**Implants for surgery — Wear of total
hip-joint prostheses —**

**Part 3:
Loading and displacement parameters
for orbital bearing type wear testing
machines and corresponding
environmental conditions for test**

AMENDMENT 1

Reference number
ISO 14242-3:2009/Amd.1:2019(E)

Figure 4 — Schematic of an orbital bearing machine configuration with two test sample setups

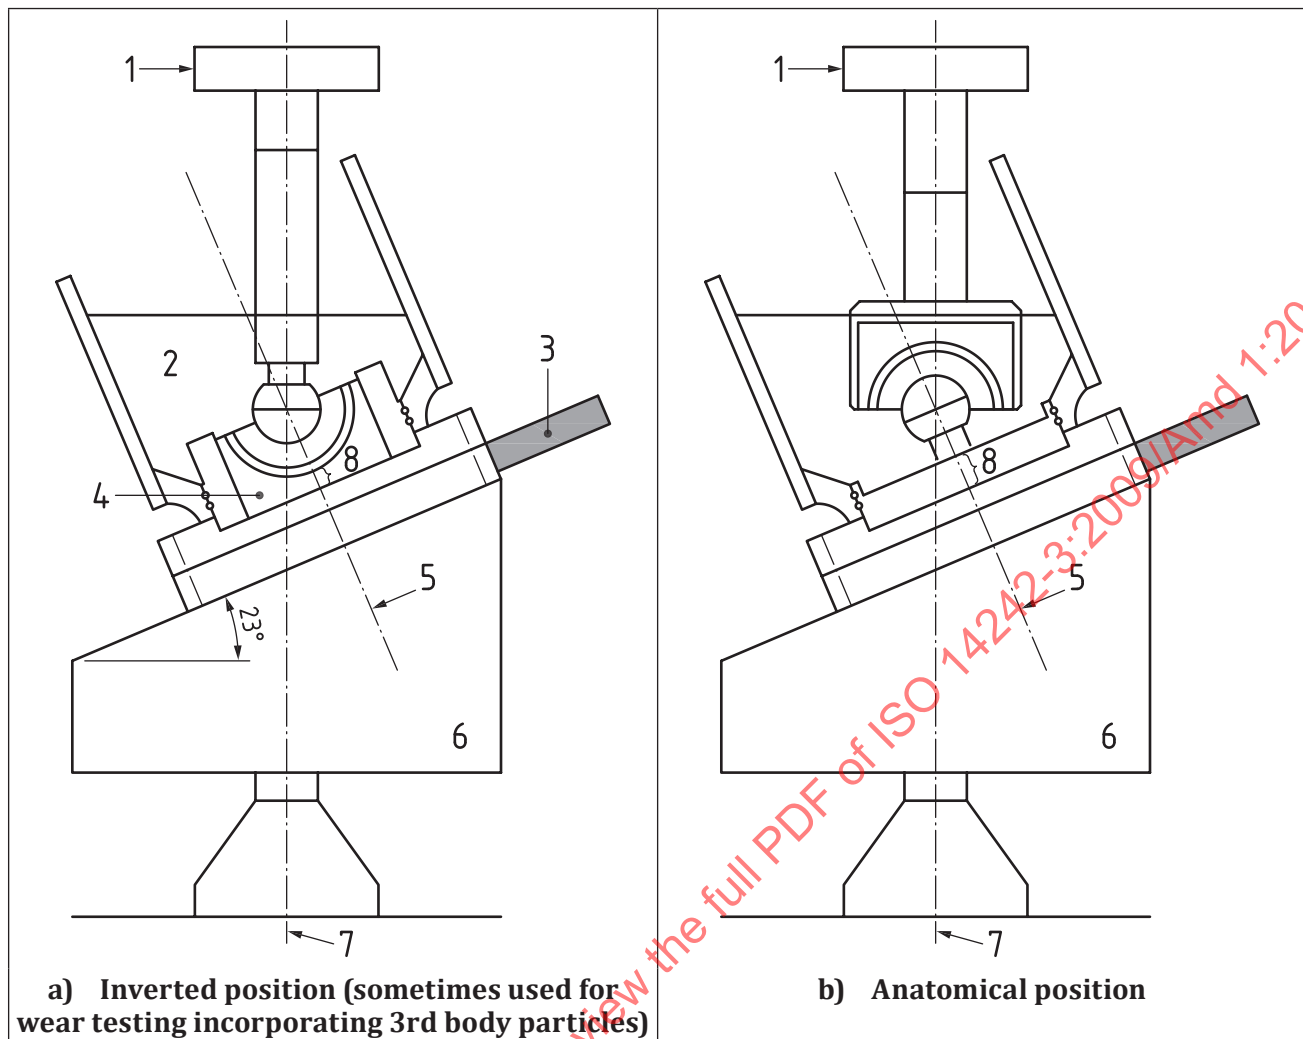
[Figure 4](#)

Replace the figure with the following:

One testing setup, sometimes used for wear testing incorporating 3rd-body particles, is the “inverted position”, that is, head above liner [Figure 4 a)]. Another testing setup is the “anatomical position,” that is, head below liner [Figure 4 b)]. The 23° angle block provides swivel to result in a 46° rocking motion, which is equivalent to an actuation of $\pm 23^\circ$ in flexion/extension and abduction/adduction (see Figure 2).

6.3 Means of aligning and positioning the acetabular and femoral component of the test specimen [for Figure 4 a), the inverted position], so that its centre lies on the axis of rotation [key 7 in Figure 4 a)] of the test machine. This is achieved by calculation based on engineering drawings and setting a suitable thickness of the cement base [key 8 in Figure 4 a)] to achieve the requirement above. The femoral component is assembled to a stem connected to a self-alignment device. The ball bearings in the self-alignment device allow the stem construct to be mobile while aligned with the compressive load.

6.4 Means of aligning and positioning the acetabular and femoral component [for Figure 4 b), the anatomic position], to ensure that its centre lies along the axis of rotation [key 7 in Figure 4 b)] of the test machine. This is achieved by calculating and setting the thickness of the femoral fixture base [key 8 in Figure 4 b)] based on engineering drawings to achieve the alignment sought above. The acetabular component is assembled to the self-alignment device and along the axis of compressive load.
